CITY OF KIRKLAND
Planning and Building Department
123 Fifth Avenue, Kirkland, WA 98033
425.587.3600 ~ www.kirklandwa.gov

MEMORANDUM

To: Design Review Board
From: Tony Leavitt, Senior Planner
Date: July 10, 2020
File No.: DRV20-00118
Subject: **EMERALD MIXED USE PROJECT
DESIGN RESPONSE CONFERENCE**

PROPOSED SITE PLAN

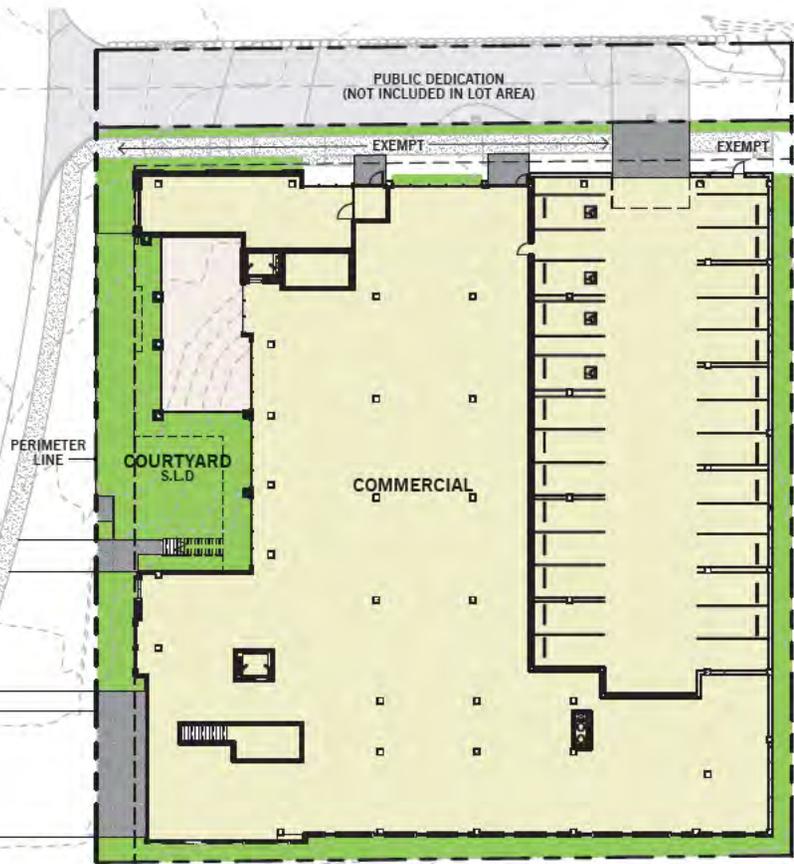
- d. 116th Avenue NE, which is adjacent to the property's west property line, angles away from the subject property when heading south (see Sheet A.11, Attachment 3). As a result, there is an increasing gap created from the street and the subject property. The northwest corner of the property is 10 feet from the 116th Avenue right-of-way curb line and the southwest corner is over 50 feet from the curb line.

g. Show added street parallel parking stalls

Response: Four parallel stalls have been added

WEST ELEVATION
SCALE: 1/32" = 1'-0"

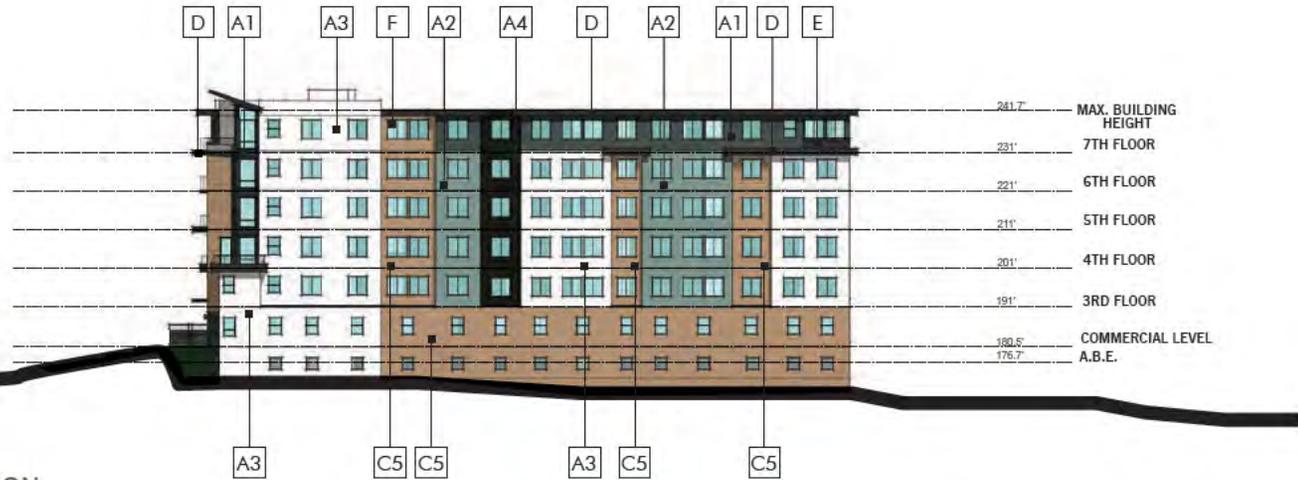
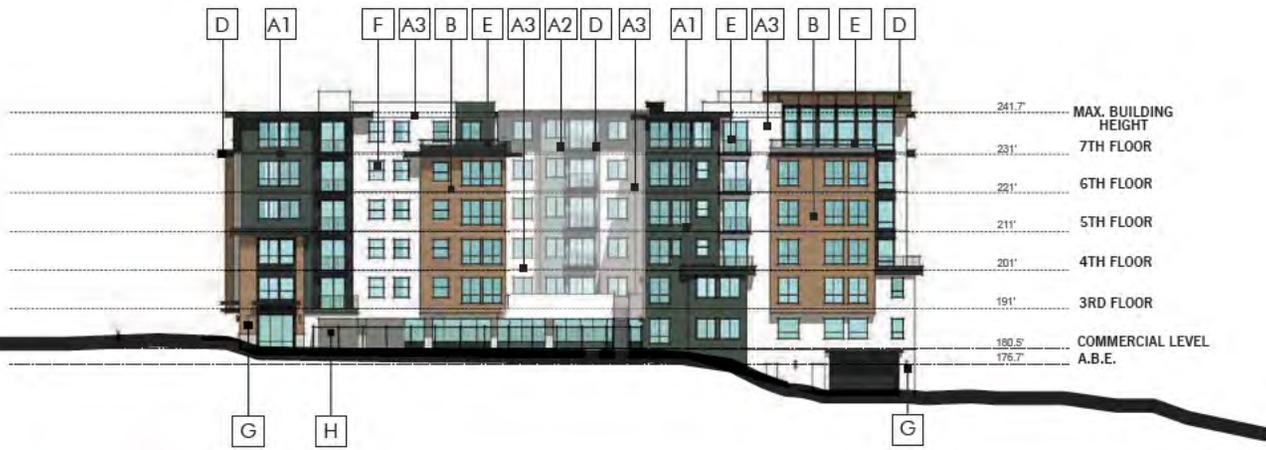
- c. *Overhangs extending into required setbacks are limited to 18" without DRB approval?*
Response: The applicant is seeking an minor variance for overhangs on the western elevation to extend beyond 18". See plan sheets A19, A20, A21. Extended overhangs are hatched in red and dimensioned. The applicant and designer feel that the overhangs strengthen the character of the architecture and emphasize its horizontality

20 windows on the Western Façade have been revised from sliding windows (with a vertical break between lites) to Single Hung windows (with a horizontal division).

CONCEPTUAL LIGHTING PLAN

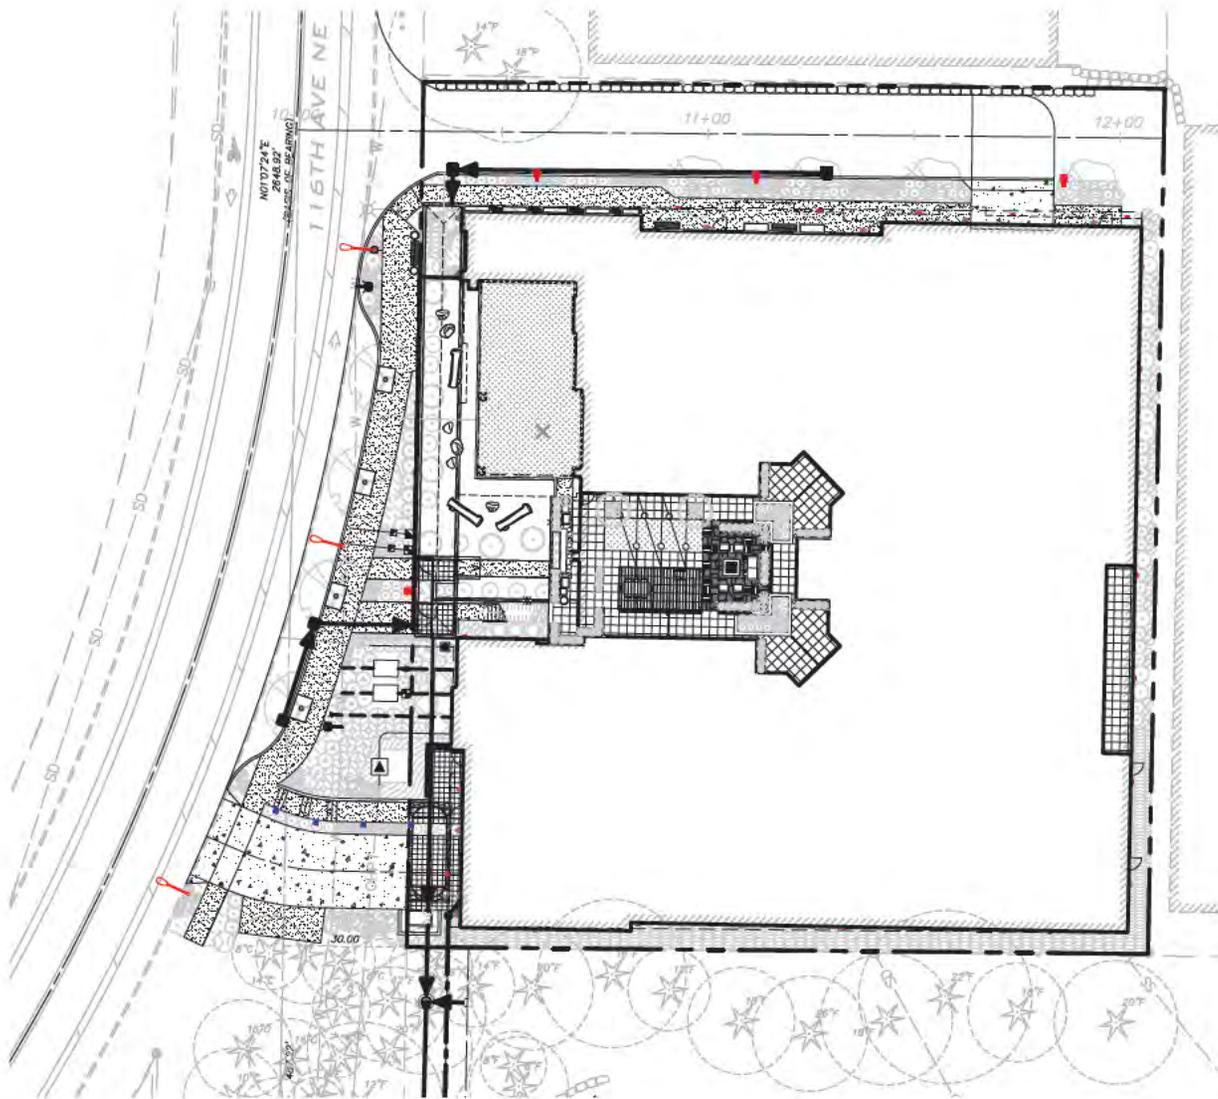
Response: Commercial exterior area and courtyard have been integrated into model
 - c. *Add Site and building lighting*

Response: Conceptual Lighting Plan has been added
